**Re: Monterey Bay Shore Ecoresort Project
A-3-SNC-98-114-EDD (Security National Guaranty, Inc.)**

Hearing: Dispute Resolution (Condition Compliance), May 15, 2015

4 5
SIGNAGE AT TUNNEL

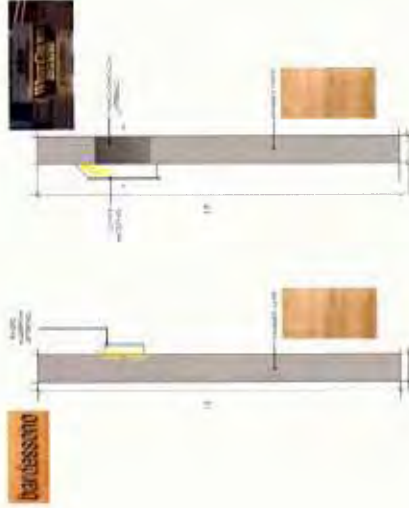
The Staff Report (on Page 12) completely mischaracterizes the size of each of the resort entry signs. The accurate size of the signs was detailed in SNG's March 9, 2015 letter (at pages 6-7) requesting dispute resolution, but, as noted, that letter was not included in the Staff Report. The plan sheet containing the signs accompanies this letter as **Exhibit 4**.

“The tunnel signs are subordinate to the retaining wall with landscaped terrace and dune behind it and provide the public with signage indicating the main entry to the resort at the round-about, as does signage that directs the public to public parking facilities and the trail to the beach at the round-about location. The large dune at the tunnel rises to over 100’, and a 3’ sign is clearly subordinate to the dune behind it.”

“The purpose of the round-about is to provide smooth traffic flow at the main entry to the resort. The Monument at this location has a dual function. With its sculpted shape, color, and texture that mimics the surrounding dunes, it screens the main tunnel (as staff previously requested) and also provides an architectural context to the resort entry along with the Cypress tree that gives it a Monterey Peninsula context. Because of the sculpted surface available, it doubles as additional signage. As to this Monument only, we can reduce the height to 10’. But as to the rest of the signs, no changes are required to meet the stated permit conditions. The signage plan shows the design and scale of all entry signs.”

Figure 3 - Conservation Easement

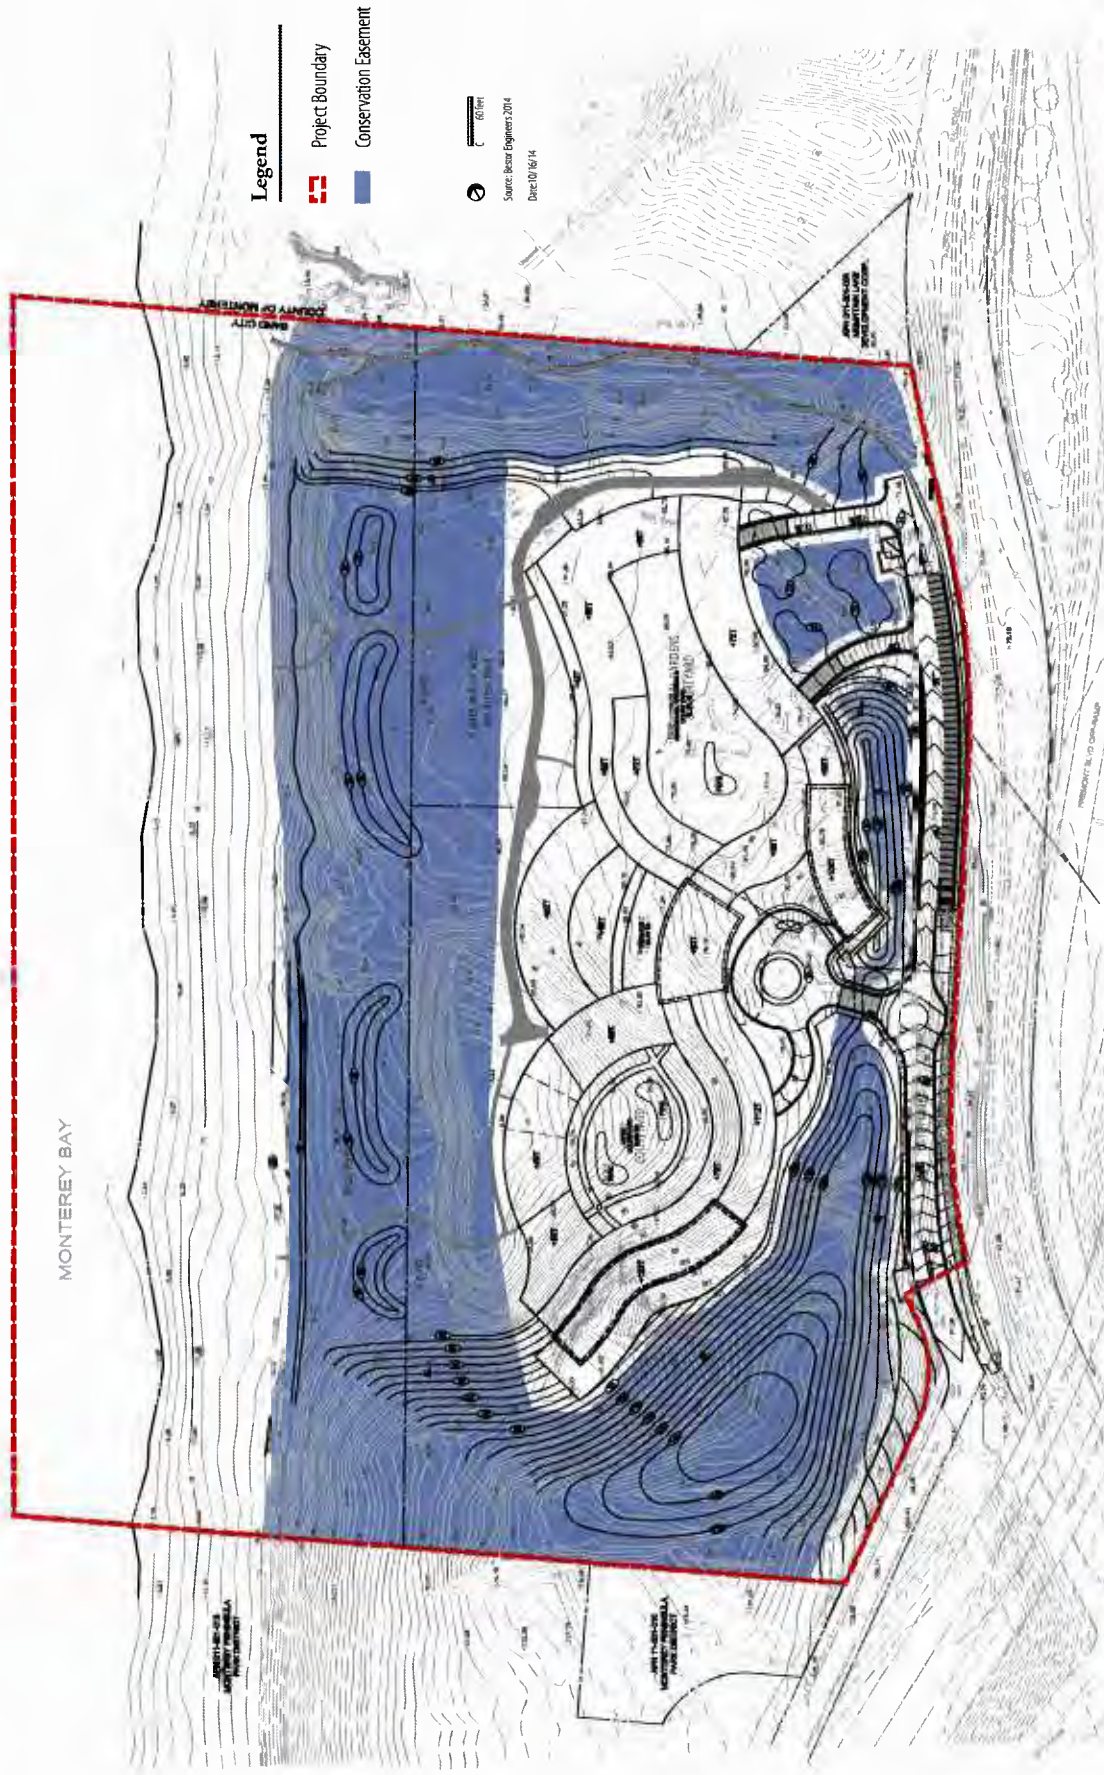
24. Special Condition 3 (Dune Restoration Plans). You incorrectly state that figure 4 of the dune restoration plan still does not cover areas outside the development footprint. The developed areas are not a part of the dune restoration areas. You also state that the dune conservation area depicted in figure 3 (“Conservation Easement”) does not comport with Special Condition 4. We disagree (please also see our comments in #25, below). Staff has repeatedly called developed area to be dune restoration areas when clearly that is not the case nor was it intended by the Commission or Exhibit 11a.

SITE FENCING PLAN Monterey Bay Shores Resort

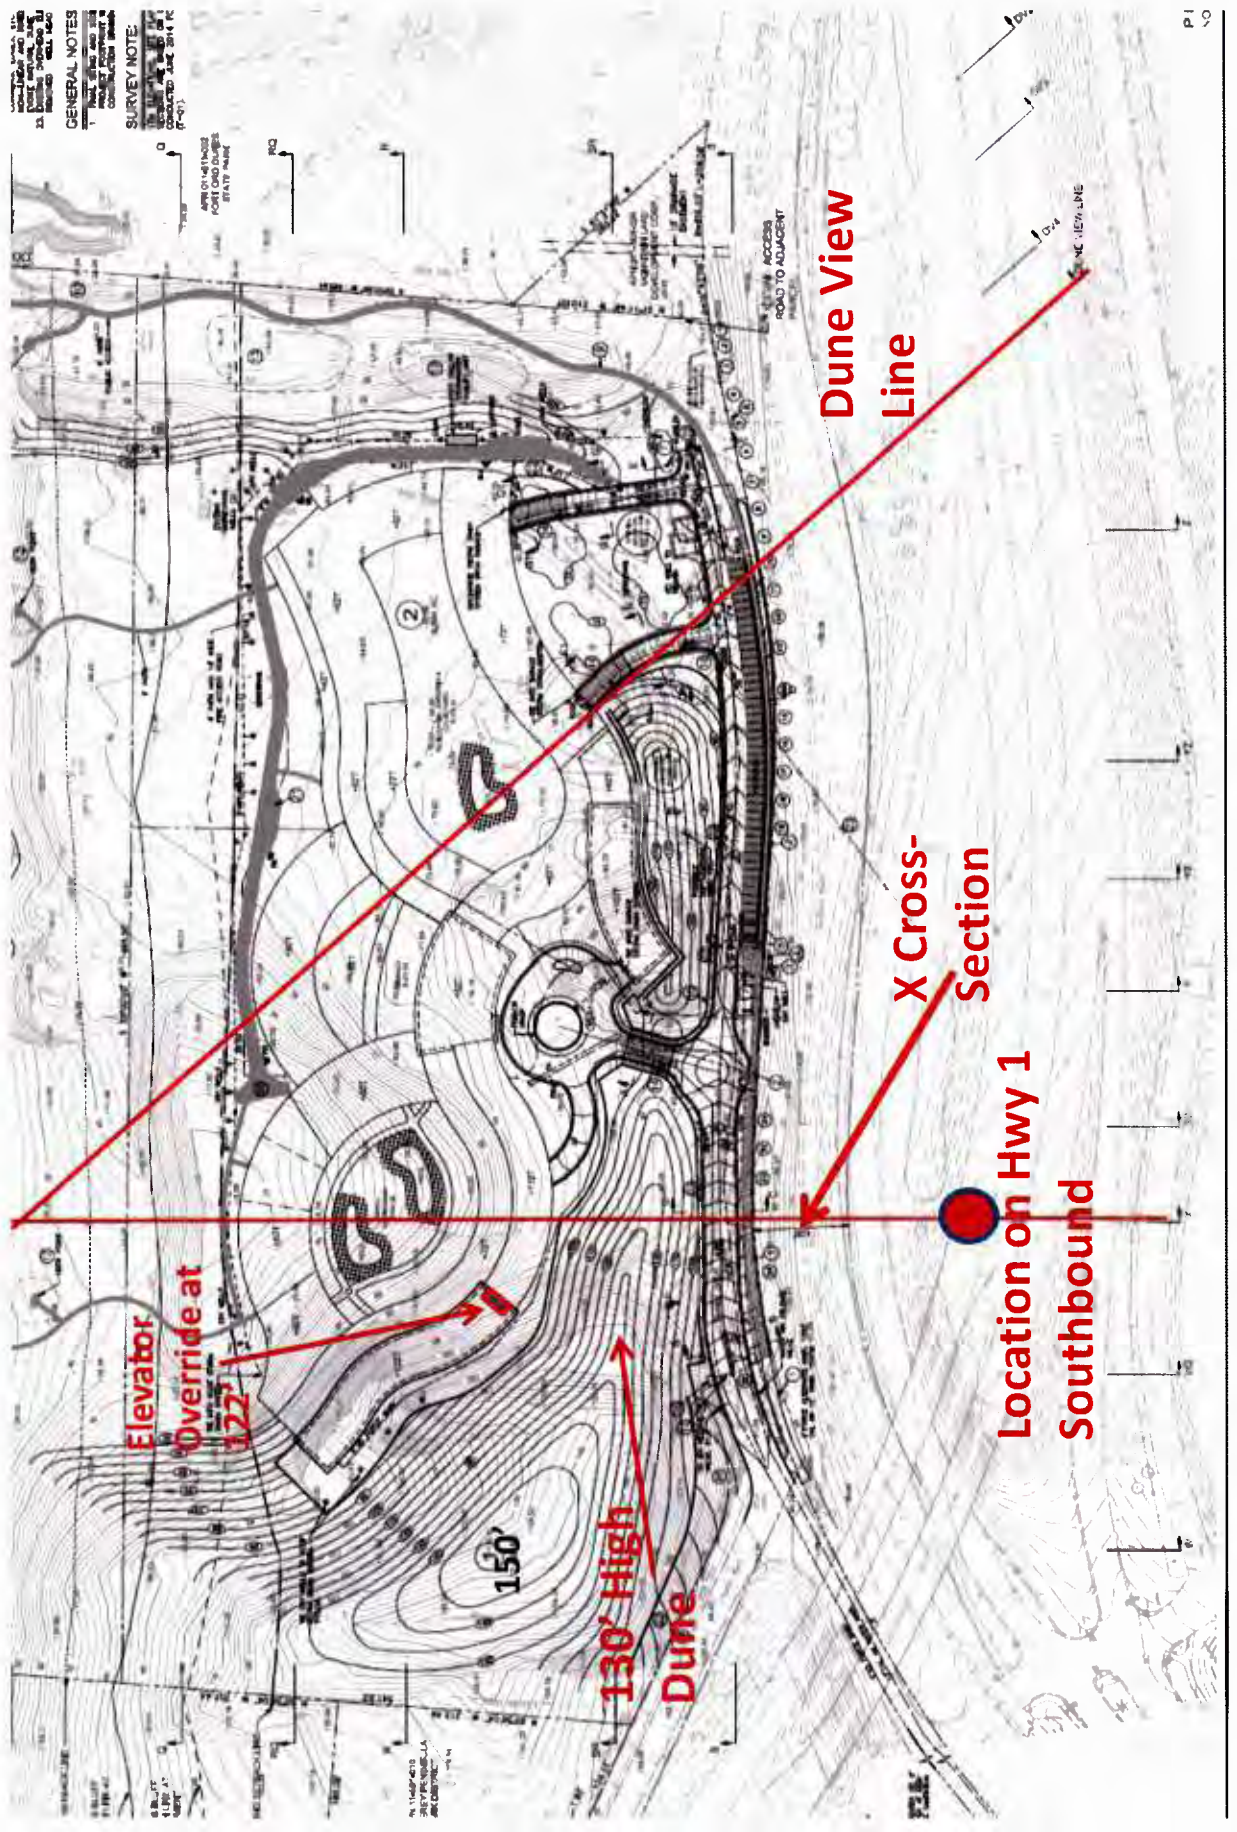
The Staff Report asserts this fencing is inconsistent Special Condition 1(u). This is inaccurate and misconstrues the permit condition: "All existing site fencing shall be removed and replaced with the minimum amount of fencing necessary to meet project objectives, and where such replacement fencing is minimized, sited and designed to be compatible with the dune landscape (e.g., rough-hewn wooden split rail, low rope and pole barriers for restoration areas as needed, etc.) and to minimize public view impacts to the maximum extent feasible." (Emphasis added.)

Staff mischaracterizes the fence as a "6-foot solid fence." It is not. It will consist of 3-4" planks each separated by 6", as shown in the image on the Landscaping Plan, page 4, which accompanies this letter as **Exhibit 7**. The fence sits at the very bottom of the restored dune and blocks no views of anything. The dispute centers on the words in the condition, "necessary to meet project objectives." As to the downcoast fence, the project objectives here are clear: the perimeter fence is necessary (1) to protect the large (to-be-vegetated) dune from "dune abuse" that historically has plagued this dune, (2) to provide security in the area downcoast behind the buildings where security otherwise would not be readily possible; and (3) to ensure safety, since the large dune slopes to the rear of the buildings on the property and historically has been used for "sand boarding." The Staff Report erroneously suggests that access on to the property and over the large dune is "largely anecdotal." Our March 9, 2015 letter explained (at page 12):

21. Special Condition 1(u) (Fencing). You state that the 6-foot tall redwood perimeter fence (located primarily on the southern boundary, and a portion of the northern boundary near the Highway) with 6” planks that is shown on LP-04 is incompatible with condition 1(u). This is inaccurate and misconstrues the permit condition: “All existing site fencing shall be removed and replaced with the minimum amount of fencing necessary to meet project objectives.” SNG has done that. Security objectives are of paramount importance in those locations, as are aesthetics, but elsewhere we have provided split-rail fencing which, while minimizing view impacts, is not secure. As Tom Roth and I explained to you at our January 15, 2015 meeting, the perimeter fencing is indeed necessary to deter trespassers. Your
